SB-GA8-2009-56

Issue 3

Service Bulletin

Overheating of overhead electrical connection used by cabin fresh air blower.

Figure 1: Connector P104 / J104

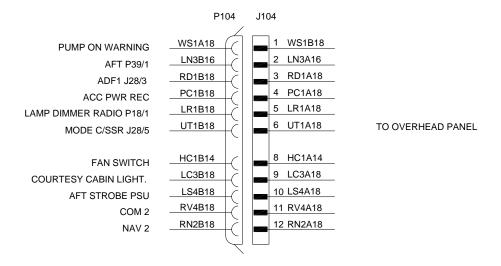
There have been some field reports indicating overheating of the connector plug J104/P104 at pin 8 between the aircraft wiring loom and the overhead electrical panel. Issue 3 gives a new, one-time, modification to address this issue.

- 1.3. Disconnect connector P104 / J104 and remove the blower fan circuits, HC1A14 and HC1B14 (Figure 1).
- 1.4. Inspect the existing 12-way P104 / J104 connector housing and replace if necessary, using Items 102 and 103 (Table 3). When replacing housing, mark Item J103 as "J104" and Item 102 as "P104" using a permanent marker.

- 1.5. Label Item 1 "J104B" and Item 3 "P104B" using a permanent marker.
- 1.6. Inspect the metal contact pin and socket for the blower fan circuits, HC1A14 and HC1B14 and replace with Item 104 and 105 if damaged or heat affected. Crimp tool HTR 11-01-0084 (Sargent Tools) is recommended for this task: Use nest B for 14 AWG wires. Install connectors to the housings at position 1.

- 1.7. Assemble connectors J104B / P104B and P104 / J104.
- 1.8. Close the underfloor circuit breakers and conduct functional tests of the blower fan.
- 1.9. Replace interior trim panels.
